## **ADDENDUM NO. 1**

### **TO SPECIFICATIONS AND PLANS FOR THE CITY OF TRAVERSE CITY**

#### **WEST END BEACH PARKING LOT REPAIR AND MDNR GRANT #TF22-0162 BATHROOMS PROJECT**

ISSUED: February 13, 2025

Date:	2025-01-21
Project No.:	2024-003
Drawn by:	JAS
Scale:	1" = 20'
Sheet No.:	3 OF 9

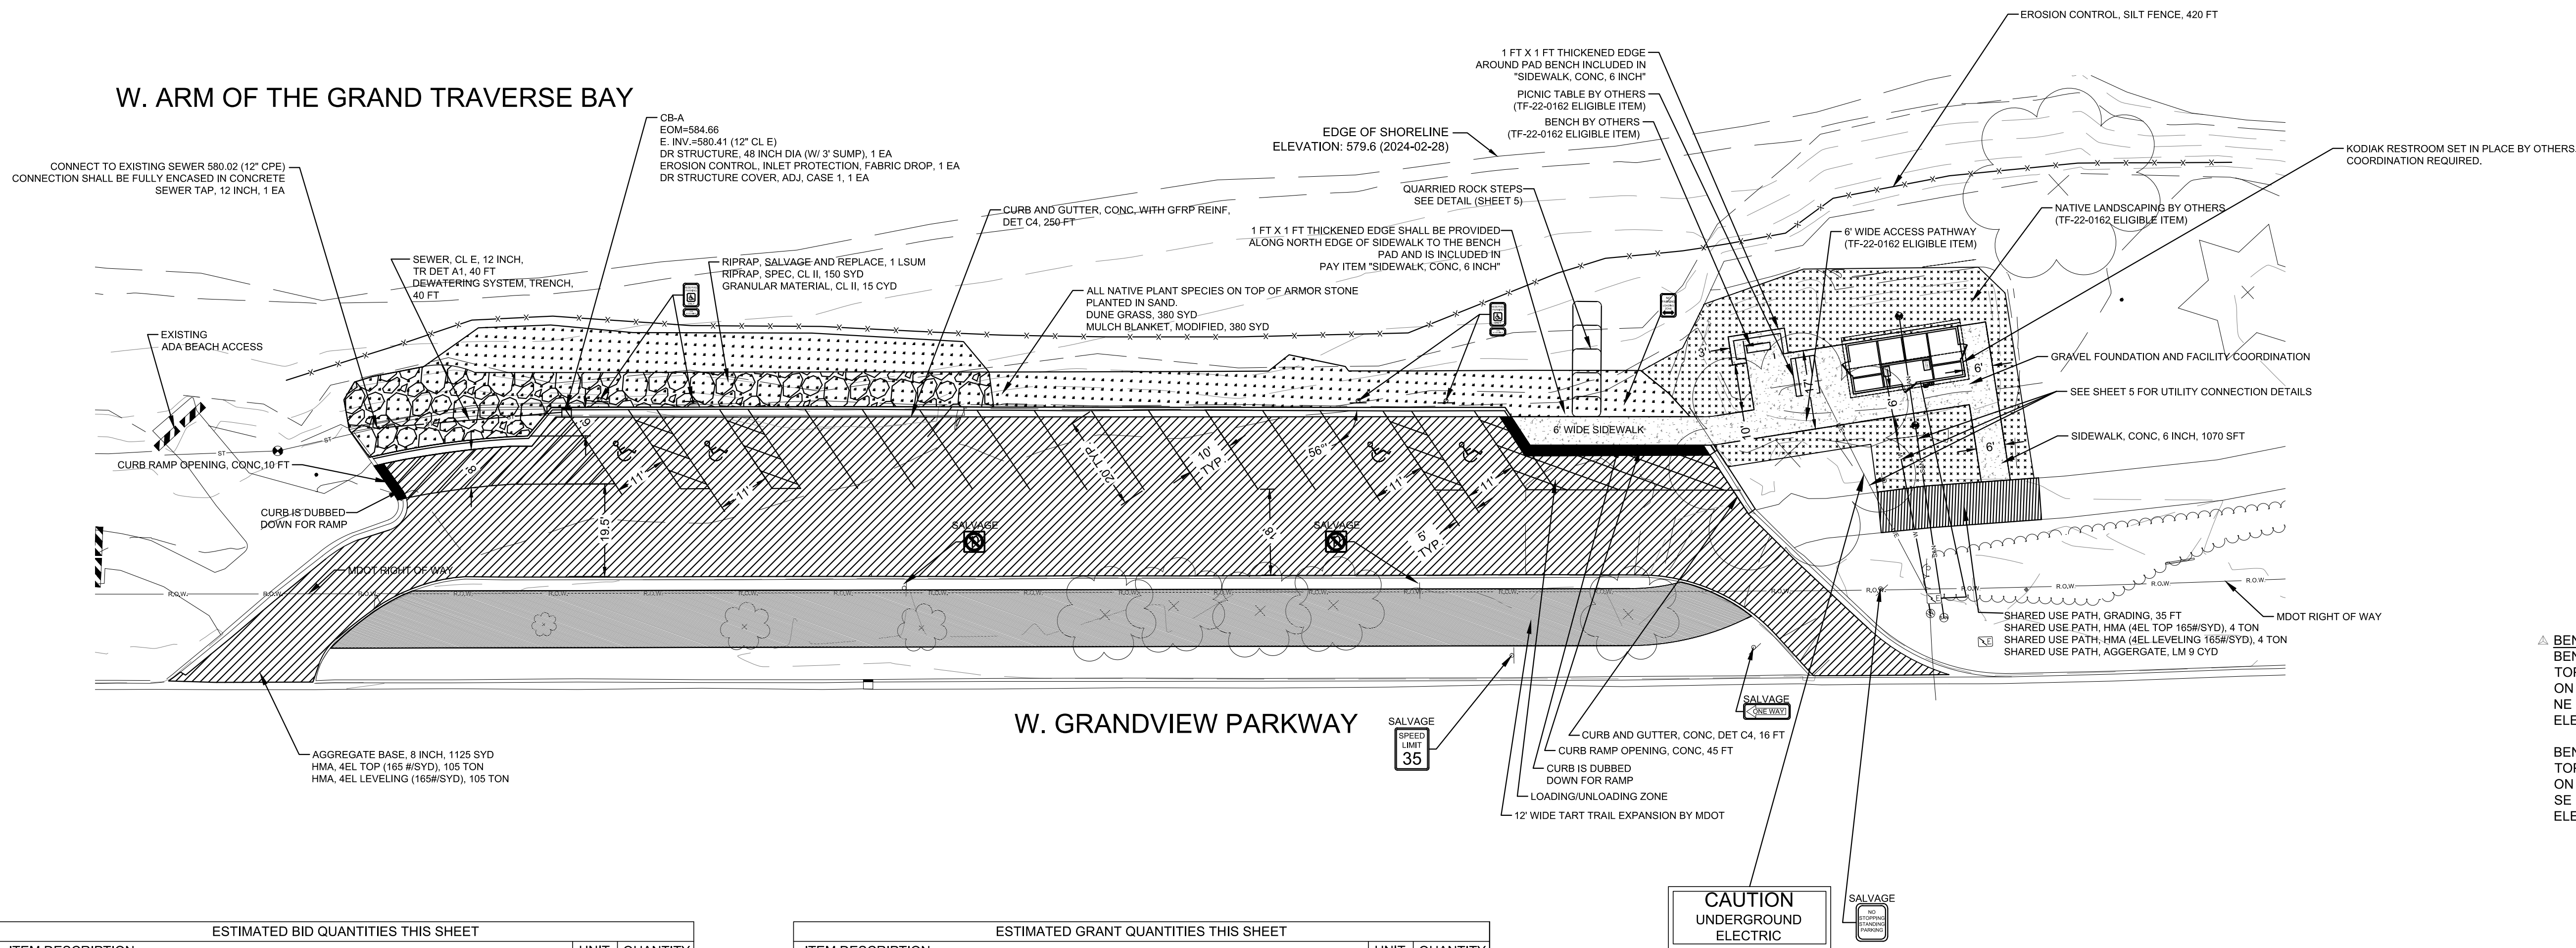
2. Question: *In the Northeast corner of the project on the removal sheet it calls out to remove structure 3266. However, on the construction sheet where the Sewer Tap 12” is placed there is a casting located there. Are we looking to remove the structure as called out then plumb into the mainline with a concrete encasement, and therefore eliminate the need for a casting?*

3. Question: *For the pipe that is getting laid it calls for 40’ of CL E pipe. However the inverts for both locations call out CPE. Will this run need to be concrete or CPE?*

5. Question: *Can clarification be provided on where the thickened edge included as Sidewalk, Conc, 6 inch is located. It calls it out on the construction sheet where the pad bench is located. However on the quarried rock steps detail the stones come off of a thickened edge. Does the thickened edge run along the entire North side of the sidewalk?*

1. Sheet 3
  - a. Added Granular Material, CI II to slope restoration area.
  - b. Casting symbol at CB-3266 location has been removed.
  - c. Added note clarifying extents of thickened edge sidewalk.
2. Sheet 5
  - a. Added Granular Material, CI II to slope restoration detail. The sand will be used to supplement the riprap to provide a void free (as much a practical) slope.
  - b. Called out Geotextile, Separator, Non-Woven, Modified material under the Quarried Rock Steps in the detail.

Answer: CB-3266 shown on sheet 2 will be removed and the casting will be salvaged for reuse on CB-A. The casting symbol at the CB-3266 location on sheet 3 is a plan error and has been removed. The new sewer from CB-A will be connected to the existing CPE sewer at the CB-3266 location with a concrete encasement and paid as “Sewer Tap, 12 inch”

Answer: The proposed storm sewer material shall be CL E concrete. The invert call out for CB-A has been corrected.
4. Question: *For CB-A will the top that is set on the structure need to be a flat top or slope cone?*

Answer: The thickened edge will be constructed along the north edge of the sidewalk from the parking lot to the bench pad and as shown in the Quarried Rock Steps detail. This will be included in pay item "Sidewalk, Conc, 6 inch"
